133-2010 ADDENDUM 2

JUBILEE AVENUE OVERPASS REHABILITATION AND ASSOCIATED ROADWORKS

ISSUED: April 12, 2010
BY: Barry Biswanger
TELEPHONE NO. (204) 477-5381

E30.4.3 Multi-use Paths

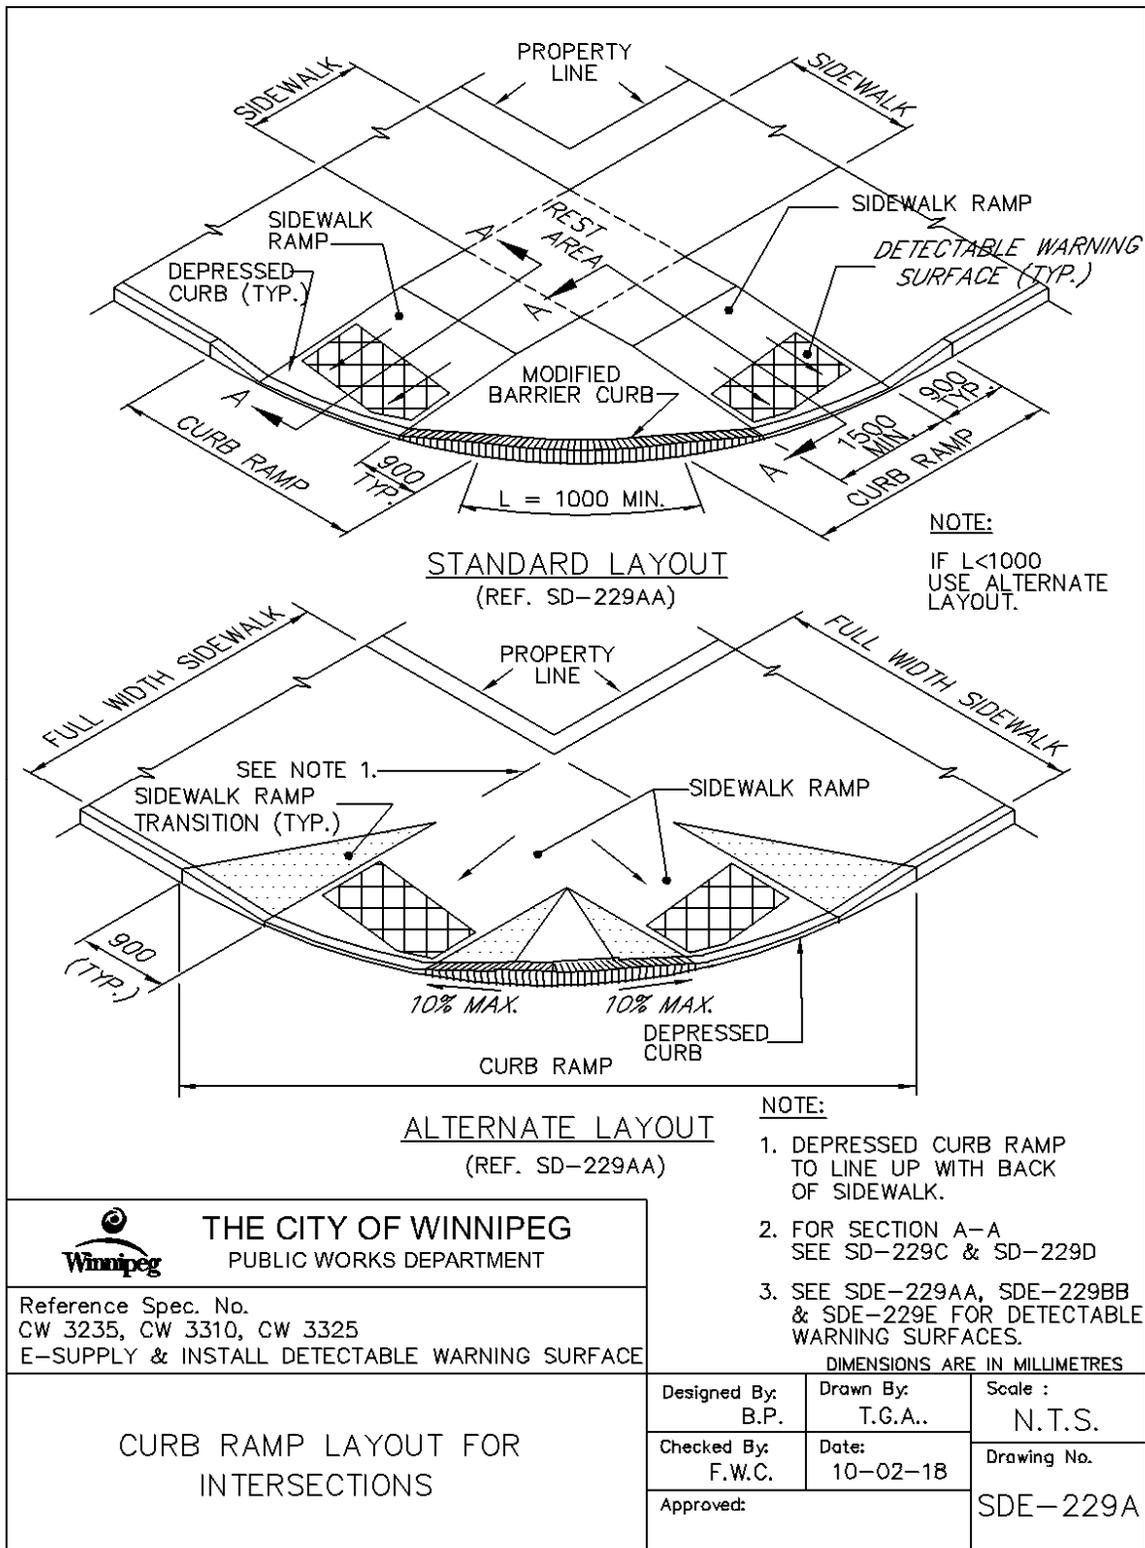
- (a) Construct a curb ramp with a depressed curb to the full width of the multi-use path in accordance with SDE-229E.
- (b) Construct a concrete ramp the width of the multi-use path and a minimum of 1.50m deep from back of curb in accordance with SD-229C and SD-229D.
- (c) Install two (2) tiles in each concrete ramp, one (1) on each side for each direction. Place the short edge of each tile 150mm from the edge of the concrete ramp, with both tiles in line with each other transversely across the concrete ramp. The tile(s) nearest the curb must be 50mm from back of curb similar to tile placement in SDE-229A.
- (d) Saw cut the middle of the concrete slab, perpendicular to the curb and to a depth of D/4. Cut additional sawcuts as directed by the Contract Administrator.
